**Stakeholder Meeting #3 Minutes: Tuesday, April 21st, 2015**  
**10:00am – 12:00pm**  
**State Route 37 Integrated Traffic, Infrastructure and Sea Level Rise Analysis**  
**Norman C. King South Vallejo Community Center**  
**545 Magazine Street, Vallejo, CA 94590**

# State Route 37 Integrated Traffic, Infrastructure and Sea Level Rise Analysis

# Inundation Mapping Revisions

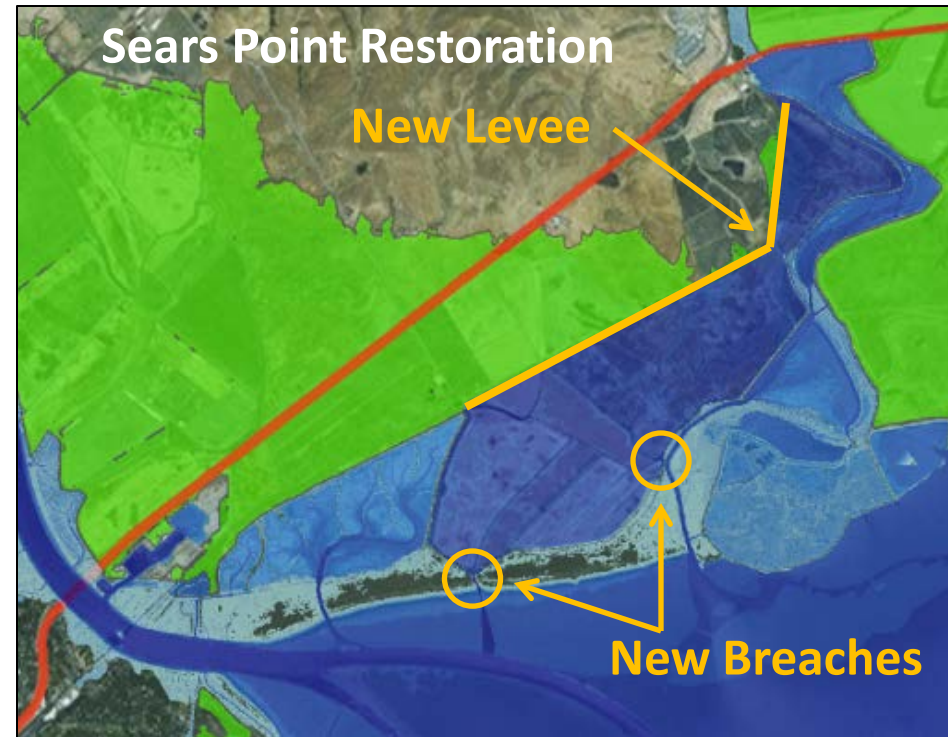
Mr. Vandever explained that the revisions on this slide were a direct result from information gathered from attendees during past stakeholder meetings. They included some areas under construction or restoration, breached levees in the model and some areas had been shown as tidal but actually were not.

# Preliminary Vulnerability Assessment: Reach A1 – HWY 101 to Petaluma River

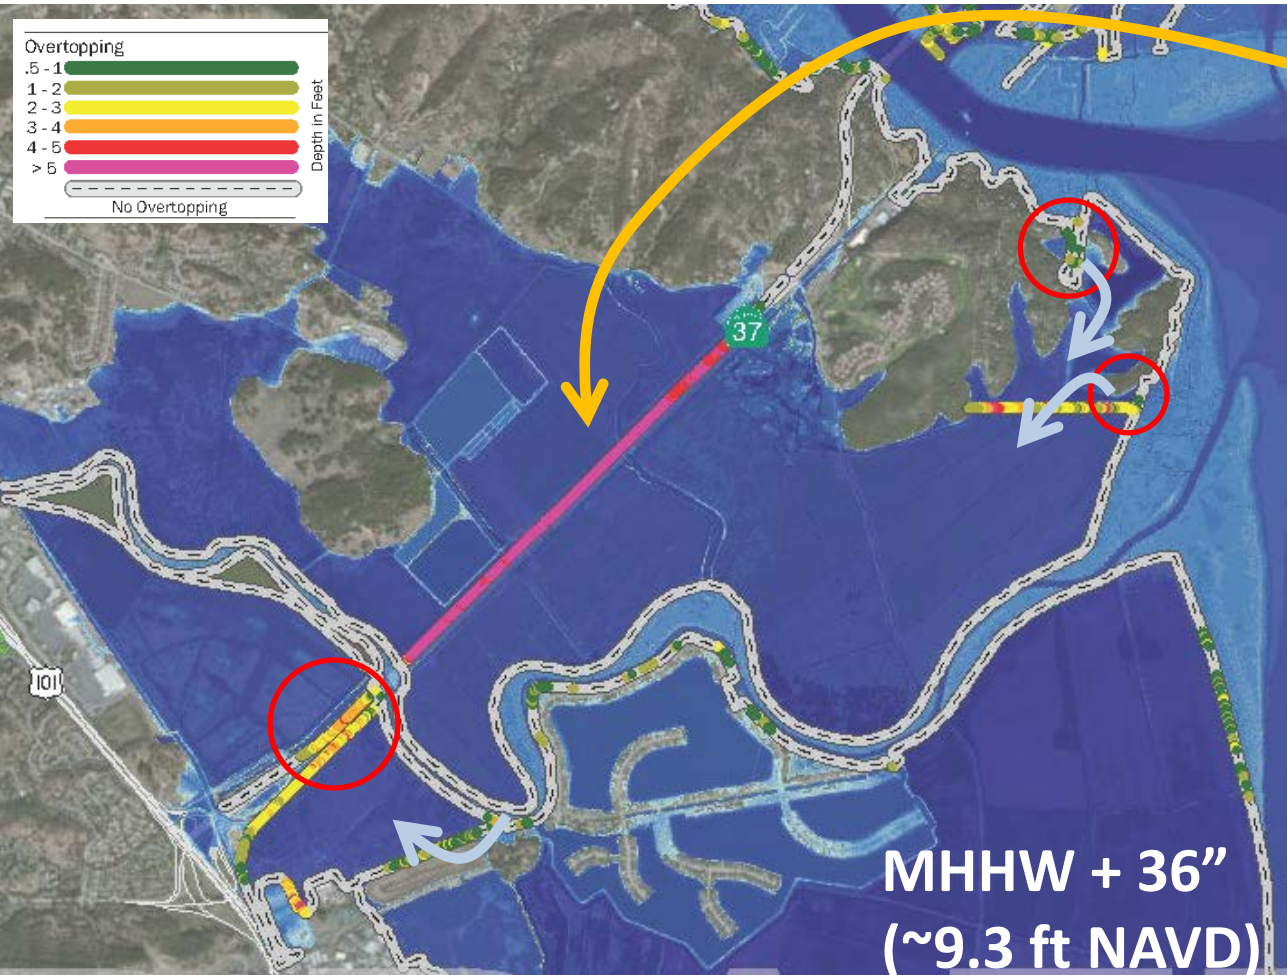
Bad news: shows scenarios very severe impact to the highway

Good news: the shoreline protection feature that is responsible for protecting it is only a very short segment.

Q: Did you compare the time that the water level was expected to be above those gaps/low points with the total volume that would be needed to create the inundation that you simulate?

Protected by a complex set of levees.

Q: Are the levee calculations based on the current elevations?

A: No, this was a mapping exercise so there were no calculations done for volume of water through a low spot or the duration. For an extreme high tide, this is a very conservative estimate of the flood impacts.

A: Everything that was part of the 2010 LIDAR data set. Some of the new levees will be added in from the restoration projects. If vegetation interfered, it could underestimate the actual height of the levee.

## REACH A: Levee

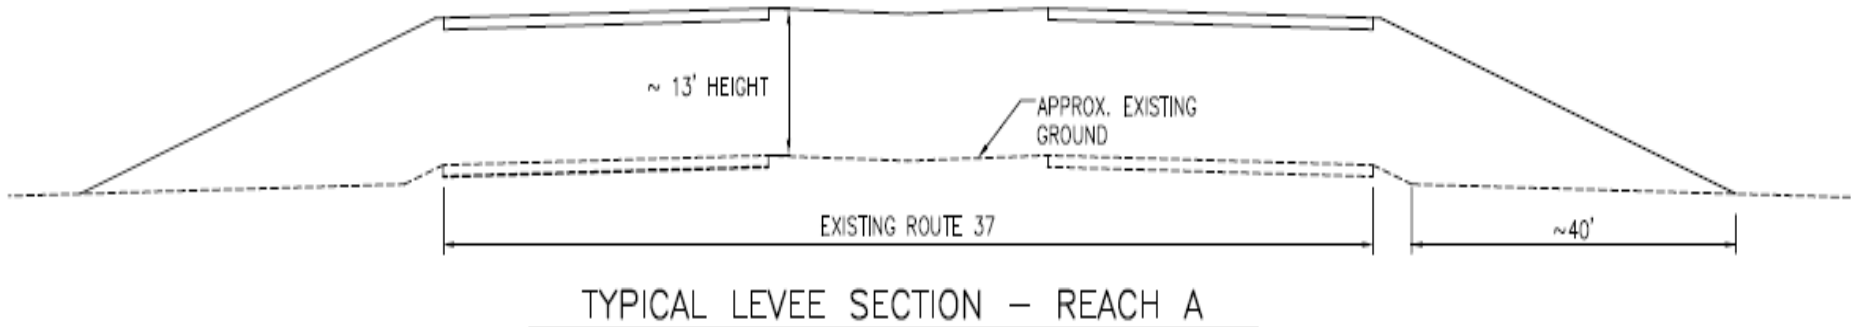
An example of a cross-section where Hwy 37 is in Reach A between Hwy 101 and Hwy 121 is a 4 lane road, 2 in each direction with a very wide median. We would maintain the same cross section of the roadway. When you raise it 13', you have about 40' of additional fill on each side of the toe.

Q: Where would the fill come from – locally or hauled in by truck?

Q: Could you eliminate the median?

A: Depends, the closer the source is the better. That is up to the contractor and where they can find the source.

A: There is a possibility but if it's narrower, you have to divide it with a concrete barrier and consider the safety aspect.

## REACH A: Monopod

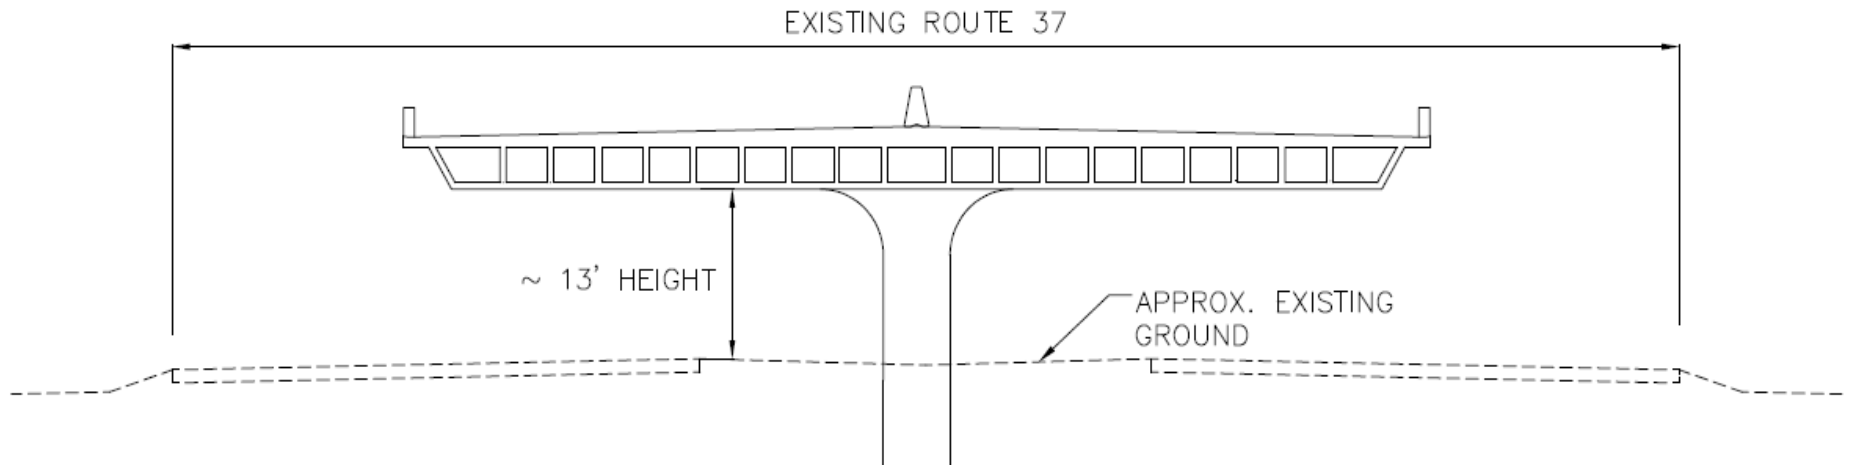
This show that the roadway is slightly narrower to minimize costs but still meet the Caltrans design requirements in terms of median width, road lane and shoulder width.

Q: How confident are you about a 70' depth for the pillar structure to get something to stand on?

Q: Is there a bedrock study?

A: It would probably be much wider and more elliptical compared to what this concept drawing looks like.

A: We haven't started that. That would be more of a consideration when we do the design. This is not the end but the beginning so that geologic studies are not done yet.

## REACH A: "Trellis"

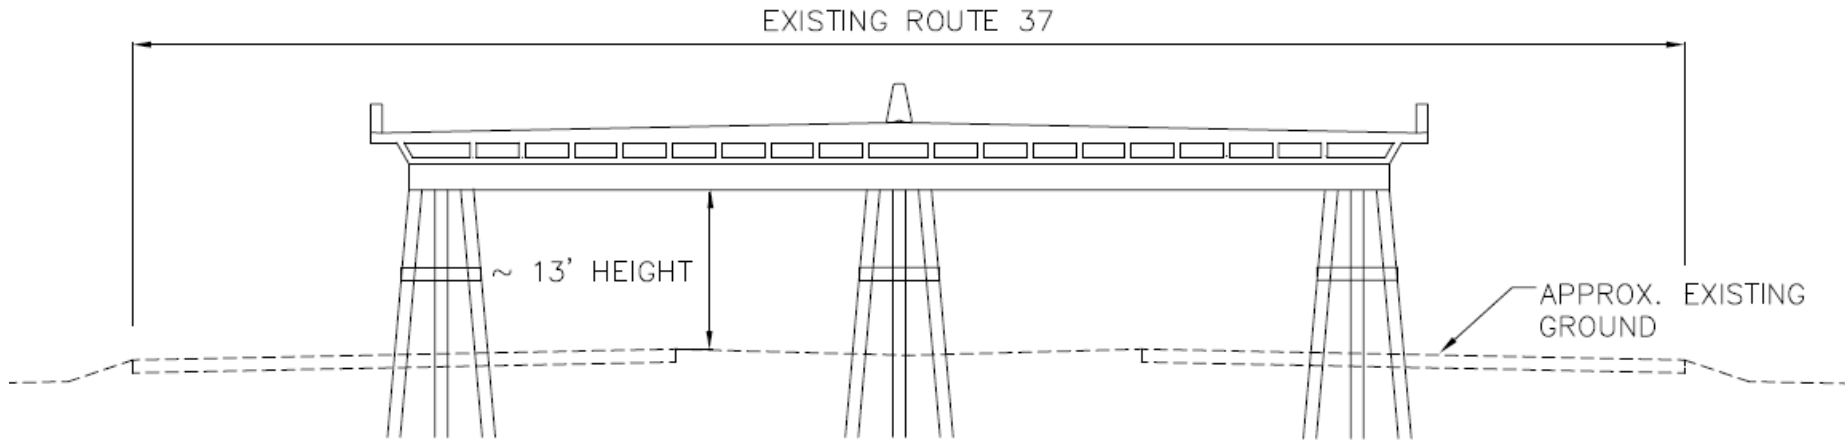
This is more of a "trestle". In this case the vertical supports for the whole width of the bridge but it will still be a narrower road width than the existing one.

Q: What is the consideration for the width of a shadow over protected habitat?

Q: But there are rules for how wide a shadow can be, maybe 70' – maybe it could be two separate roadways?

A: There are min/max requirements for lane, median and shoulder widths.

A: Yes and what might be entailed if you actually build one of these.

## REACH B: Monopod

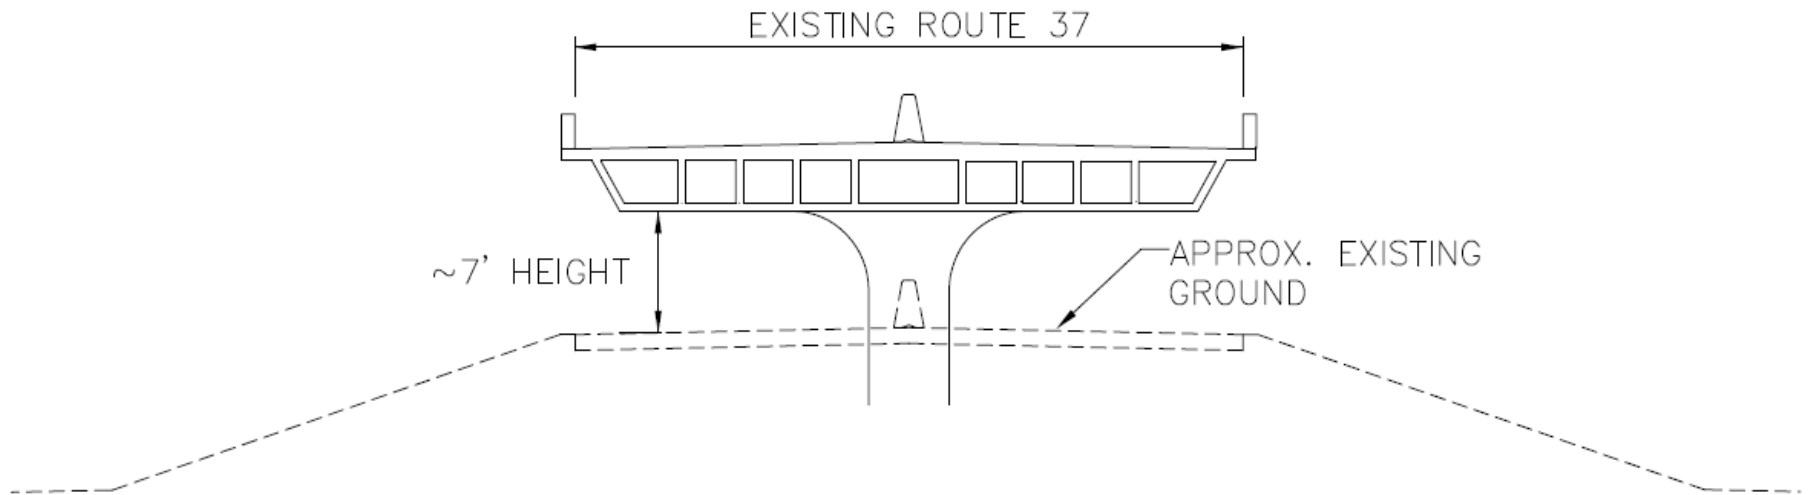
The roadway would be wider and cast a shadow but you could eliminate the roadway embankment with this scenario and open up the connection from one side to the other. That would mean a much taller column, increasing the cost.

Q: If you do that, then that will allow free flow and flooding of the properties much earlier.

Q: When you construct this, will the roadway close for construction?

Q: If Sonoma Land Trust owns it, do you have an easement to build a parallel road and not encroach on their land?

A: That is one possibility. The current roadway pavement would be eliminated

A: When you build a new roadway like this, in general, you have to either build it to one side of the roadway or the other or, you close it altogether if you are trying to maintain the existing alignment. And what assumptions do we make regarding the intersections – does it also need to be raised or not. We would like feedback on that.

A: It would require Right of Way (ROW)
